DESIGN REVIEW REPORT AND DECISION

File Number: DSRFY2026 - 0012

Review Status: APPROVED AS CONDITIONED

Tony Thurber with Anchored Architects is proposing a new multifamily residential development at 471 E. 47th Street. The proposed building is a three-story modular construction.

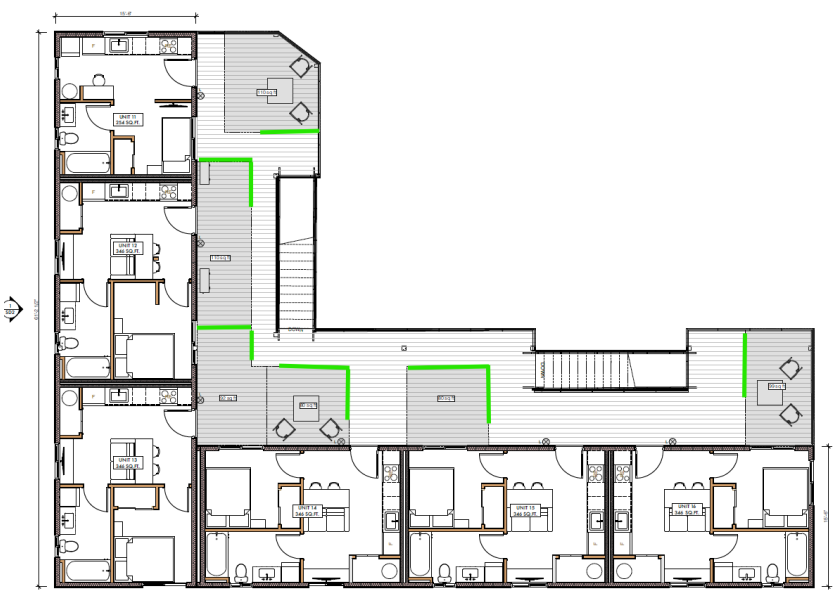
The applicant is required to provide mitigation for 94 inches of caliper.

Tree mitigation at a 1:1 caliper will be required. The landscape plan shows 22 caliper inches of new deciduous trees and 44 evergreen trees in the planting schedule. The code does not clearly specify whether evergreen trees can be counted toward mitigation. Previously, evergreen trees did not count toward tree mitigation requirements. However, in August 2025, the code was amended to include buffer requirements. The updated perimeter landscaping standards specifically require a variety of tree species, including both deciduous and evergreen trees.

To avoid conflicting with the amended code, staff determined that evergreen trees should be counted toward the tree mitigation requirements. However, evergreens are typically measured differently than deciduous trees. Standard nursery stock for evergreen trees is generally around 6 feet in height. Therefore, since the applicant is proposing 8-foot-tall evergreens, staff may conditionally consider them equivalent to 3-inch caliper trees, consistent with the proposed deciduous tree sizing.

Total proposed tree mitigation: 159 inches of caliper. **These figures may change depending on the caliper of the trees ultimately selected. The required total of 94 caliper inches is for mitigation trees only and does not include any trees otherwise required by the code.**
